UNITED STATES PATENT AND TRADEMARK OFFICE

APPLICATION NO.	FILING DATE	FIRST NAMED INVENTOR	ATTORNEY DOCKET NO.	CONFIRMATION NO.
09/887,877	06/21/2001	Donald Brian Eidson	01827.0037.CPUS01	9000

Office Action Summary

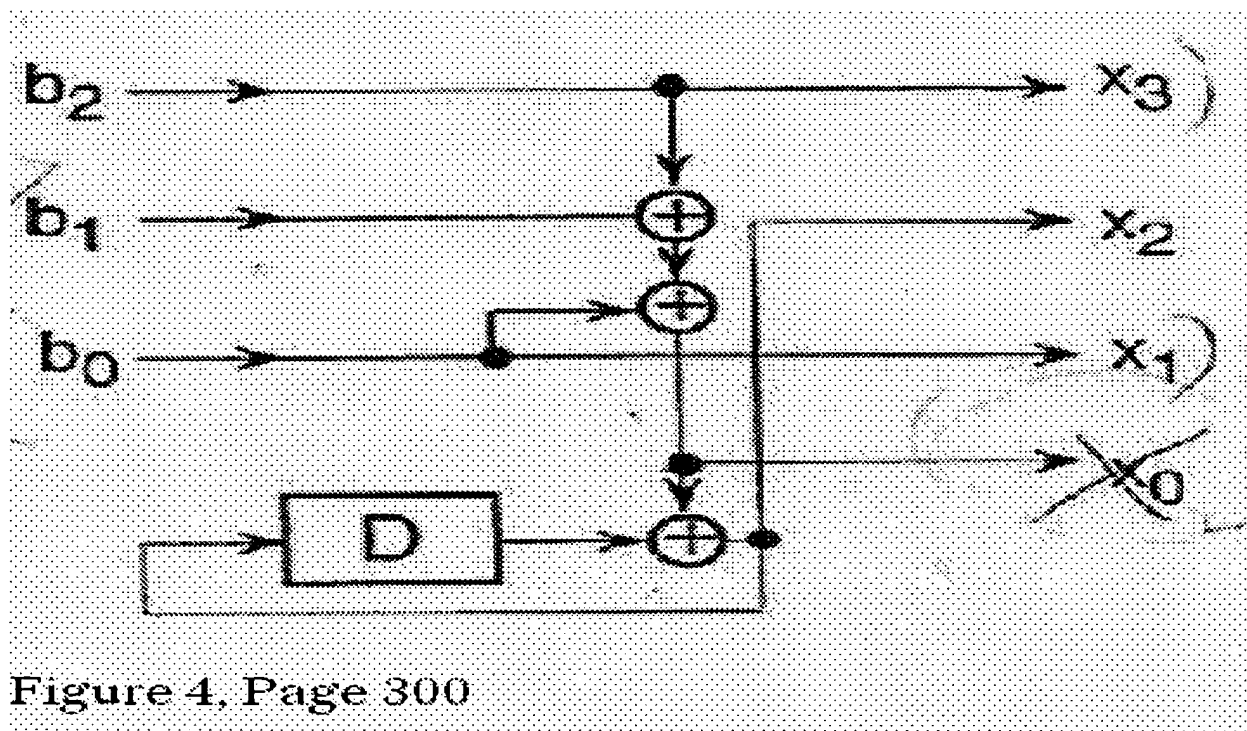
As per claims 1 and 54, Benedetto et al. (herein after: Benedetto) substantially teaches the limitations in claims 1 and 54 of the present application through Figure 3, page 295; Figure 4, page 300 and Figure 8, page 339. For example, Claim 1 of the present application recites: A rate n/n recursive, systematic convolutional encoder which comprises: n inputs, wherein n is an integer greater than 1; n parallel outputs; an adder having $(n+1)$ inputs and an output; and a feedback loop, including one or more storage elements in series, coupled to the output of the adder and to an input thereof, the feedback loop and the one or more storage elements being characterized by a prime polynomial; wherein all n encoder inputs are input to the adder, $(n-1)$ of the encoder inputs are passed through unaltered to form $(n-1)$ of the encoder outputs, and the n^{th} encoder output is derived from the feedback loop. The following figure is imported from Benedetto's reference.

The Examiner would like to point out that in the above Figure 4, Benedetto teaches the limitations of claim 1 with slight modification. The following description is in reference to Figure 4 above: The adder connected to the output of the delay element has $(n+1)$ inputs, which are b_2 , b_1 , b_0 and the output of the adder. The output of the adder is formed in a feedback loop that includes a storage element. Furthermore, two of the three inputs of the encoder are unaltered, namely b_2 and b_0 , whose respective outputs are x_3 and x_1 .

Benedetto does not explicitly teach a rate n/n encoder as stated in the present application. The Examiner would like to point out that it is well known in the art that a rate of an encoder is defined as the ratio of the number of inputs to outputs. The limitation of claim 1 of the present application states a rate n/n , which essentially means that the number of inputs is equal to the number of outputs. Referring to Benedetto's Figure 4 above, one of ordinary skill in the art at the time the invention was made would have recognized that by eliminating output x_0 would indeed have made the above-shown encoder a rate n/n . This modification would have been obvious to one of ordinary skill in the art because one of ordinary skill in the art would have recognized that by eliminating the x_0 output of the encoder taught by Benedetto in Figure 4 would have increased the coding gain at relatively low bit error rates. Furthermore, the Examiner would like to add that by removing the x_0 output also would have been an obvious design choice and not patentably distinct.

As per claims 2-3, Benedetto substantially teaches, in view of above rejections and Figure 4 above, a feedback loop that includes a single storage element wherein the input of the storage element is coupled to the output of the adder, and the output of the storage element is
